TENNESSEE DEPARTMENT OF TRANSPORTATION
EROSION PREVENTION/SEDIMENT CONTROL
INSPECTION REPORT

State Route (SR) / US Route or Road Name and Description: Wolf River Blvd.			Are corrective actions required by this inspection report (Y/N):			
County(ies): Shelby	TDOT PIN: 101615	NPDES Permit (NOC) #: TNR153299	Number of New Corrective Actions:	Number of Recurring Corrective Actions:	Number of New Sediment Releases:	Number of Un-Corrected Sediment Releases:
TDOT Construction No.: 7994-1535-54	TDOT Contract No.:	Contractor: Acuff Enterprises Inc.	/	/	0	0

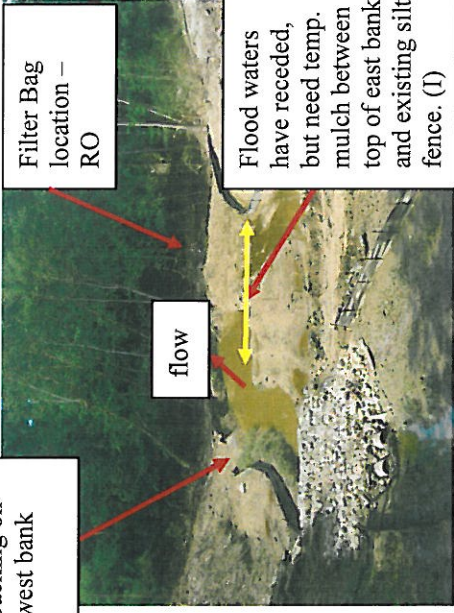
<p>Reinstall ± 20 L.F. silt fence with backing on west bank</p>	 <p>Filter Bag location – RO</p> <p>flow</p> <p>Flood waters have receded, but need temp. mulch between top of east bank and existing silt fence. (I)</p> <p>Outfall 1C Sta. 21+33 LT. Approx. Corrections are needed as indicated. (I)(RO)</p>	<p>No Picture</p>
